Town Planning and Project Services

RE: RESPONSE TO INFORMATION REQUEST – DEVELOPMENT APPLICATION FOR A MATERIAL CHANGE OF USE (DWELLING HOUSE, ANCILLARY SHED AND HOME BASED BUSINESS) OVER LAND AT 129 RYKERS ROAD, CAPE TRIBULATION, MORE FORMALLY DESCRIBED AS LOT 2 ON RP732553

Council ref: MCUC 2026_5939/I

1 PROPOSED DRIVEWAY PLAN
1 : 400

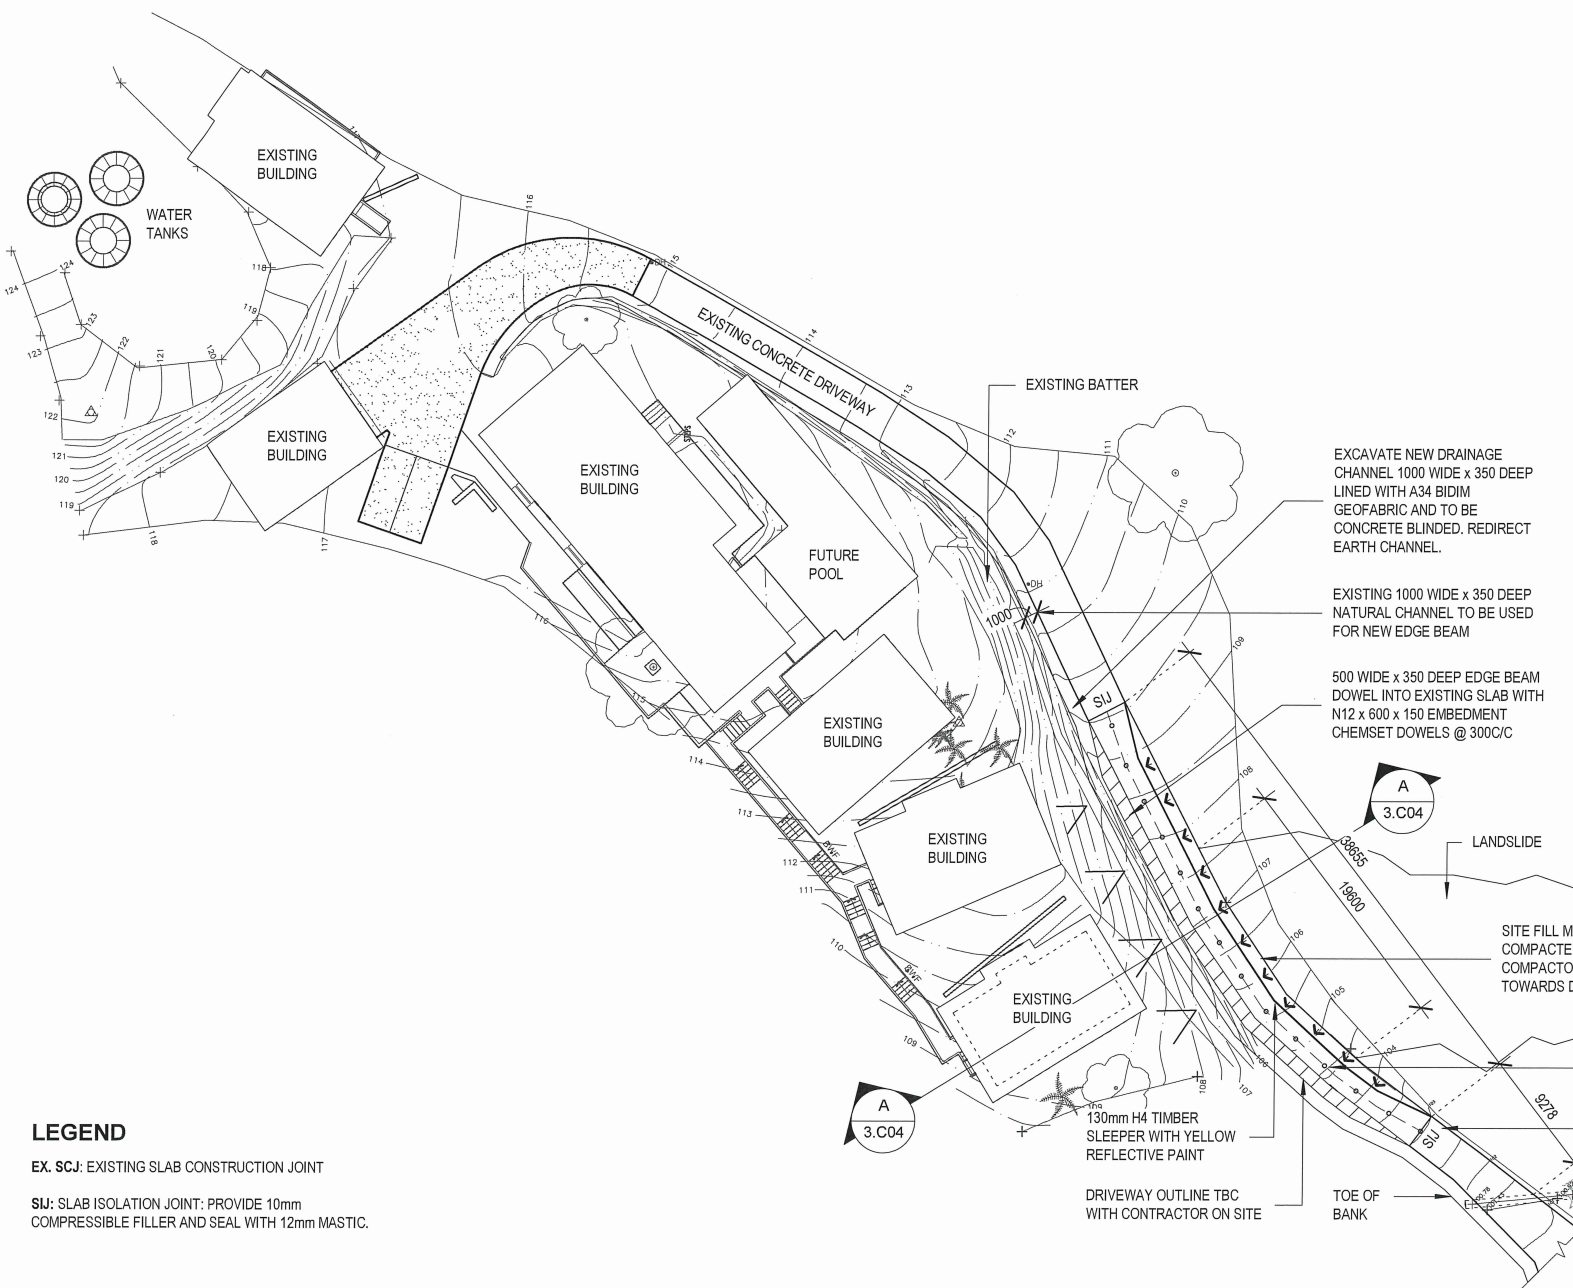
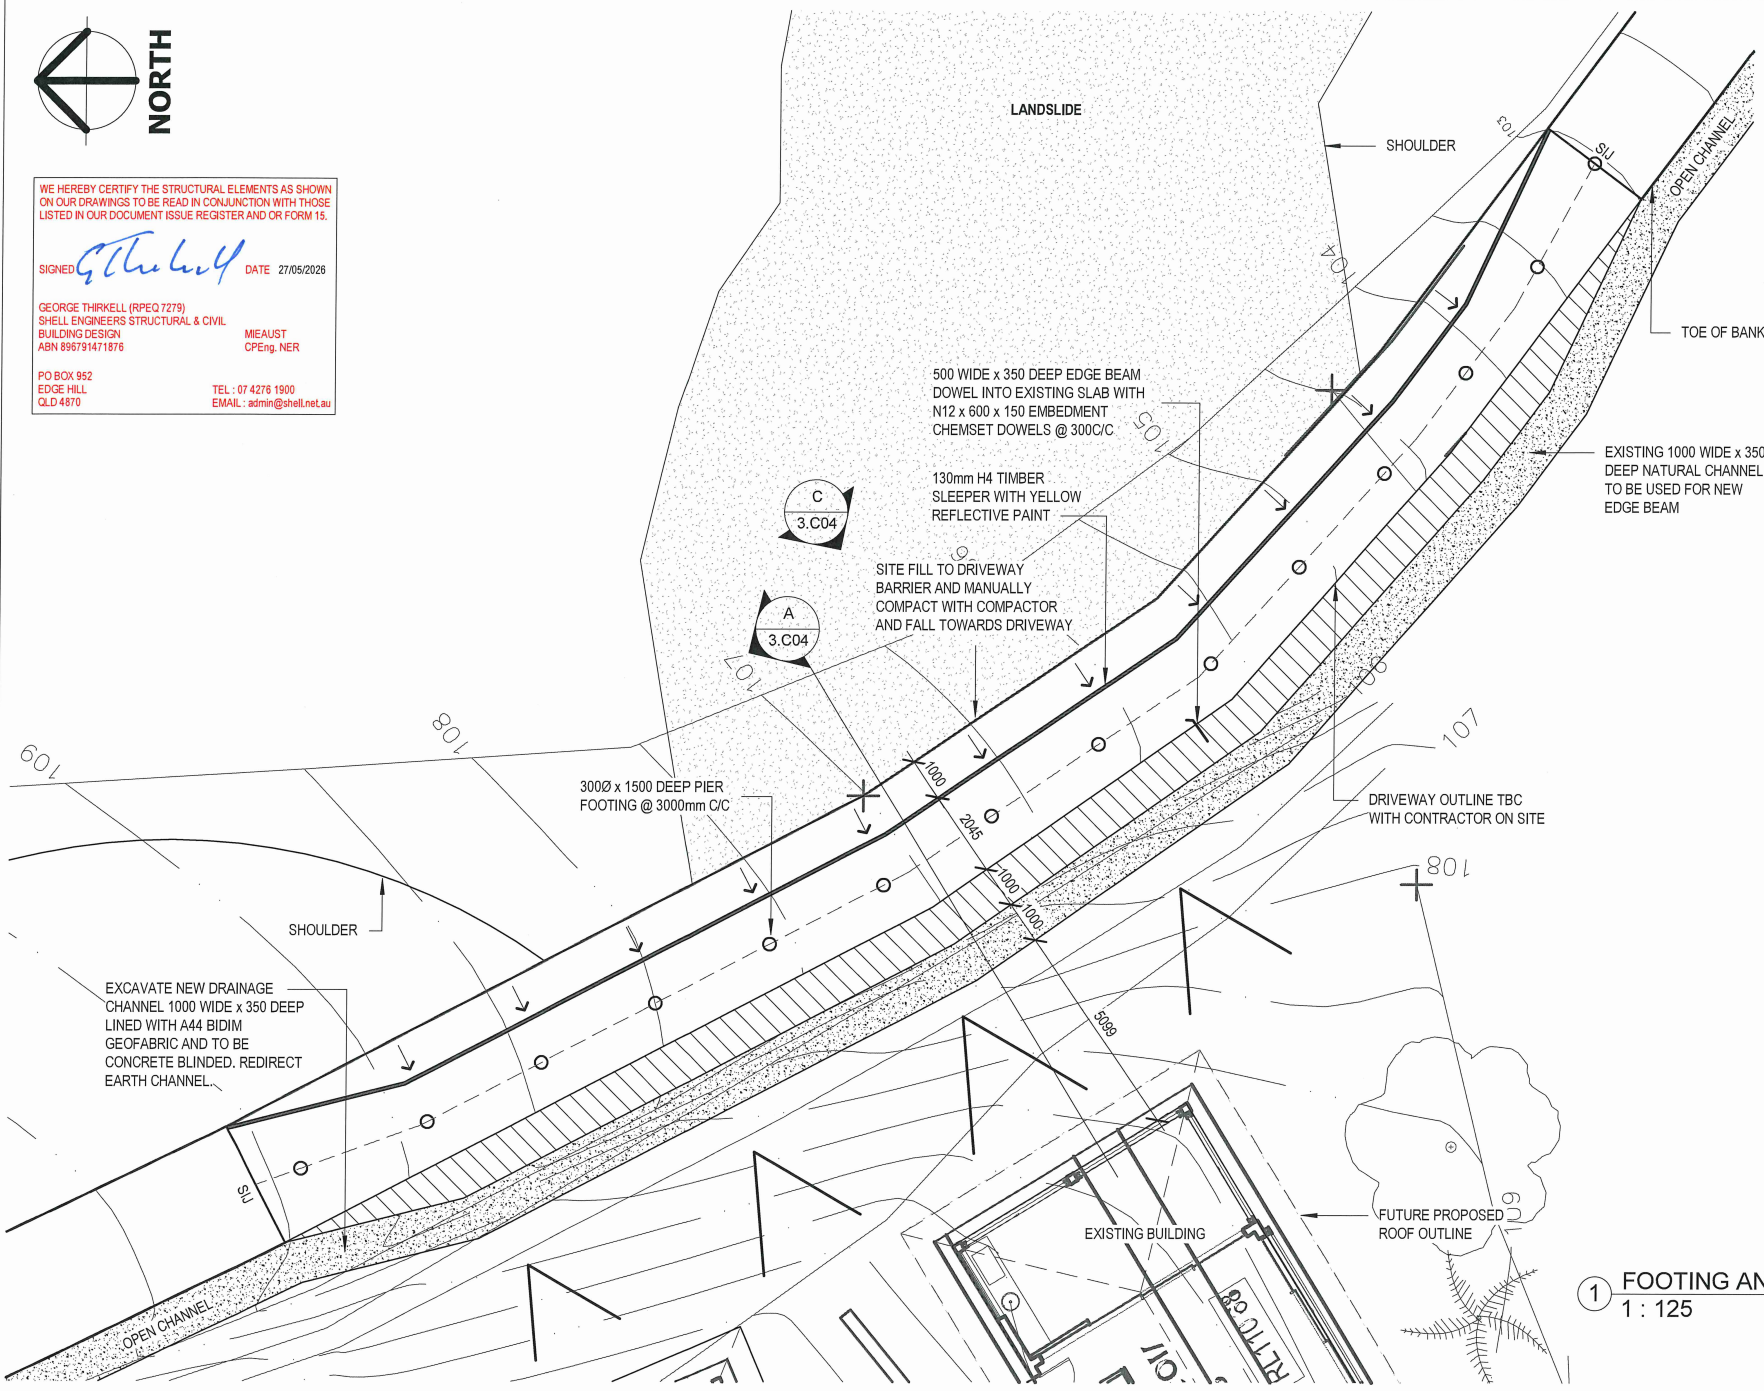
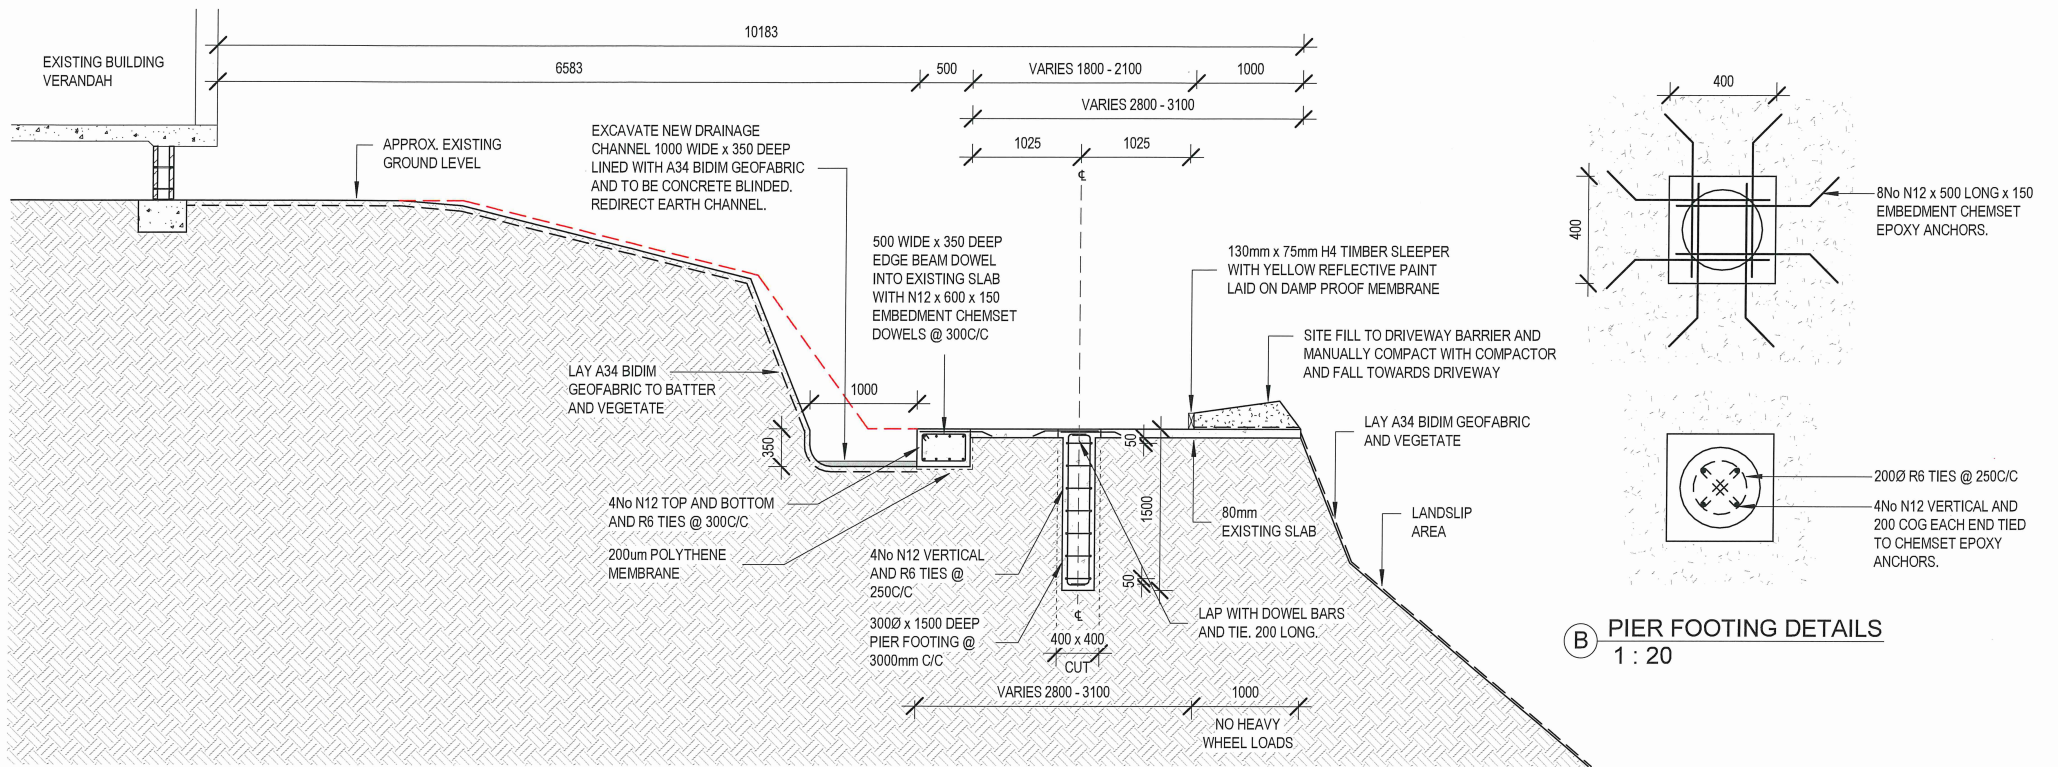
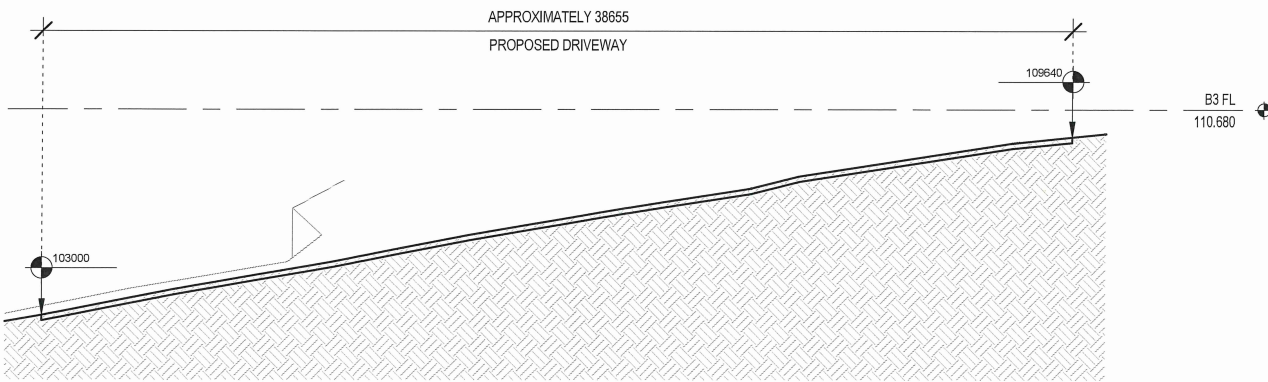
Council Officers note that the hillside supporting the existing concrete driveway at CH108 has been significantly impacted by a landslip event however the application material does not provide any engineering design or technical reporting to identify how this landslip will be managed.

Advice Note: The application triggers assessment against the Potential landslide hazard overlay code and therefore Council Officers consider it a reasonable expectation that a competent person, being a geotechnical engineer certifies the stability of the site, including associated buildings and infrastructure such as the driveway to confirm that any landslip risk or existing damage will be appropriately managed to ensure the site remains stable for the life of the development.

Furthermore, if rectification works are being proposed then an operational works application may be required.

A site-specific Landslide Hazard Assessment Statement prepared by George Thirkell, RPEQ 7279, together with detailed engineering drawings prepared by Shell Engineers, has been submitted in support of the application, refer to Attachment 2. The assessment concludes that the proposed remediation works will maintain the stability of the site and associated infrastructure for the life of the development and will not increase the risk of landslip activity on adjoining land. The report further confirms that the proposed drainage and structural improvement works represent an enhancement to the existing situation and have been specifically designed to improve the resilience of the driveway following the unprecedented rainfall event associated with Cyclone Jasper.

The engineering design includes:

- Construction of a reinforced edge beam and pier footing system to support the affected section of driveway;
- Improvements to surface drainage through provision of a new drainage channel;
- Redirection of overland flow paths away from the compromised batter;
- Soil movement is 15m³, less than 25m³ moving from one side of the road to the other, to be compacted for a new edge. No excavation or fill is being exported or imported.
- Stabilisation of disturbed areas; and

- Ongoing drainage management measures to minimise groundwater and surface water impacts.

Importantly, the engineering assessment confirms that the proposed works will not concentrate groundwater or surface water flows, will not increase the risk of landslip on adjoining land, and will maintain the long-term stability of the site.
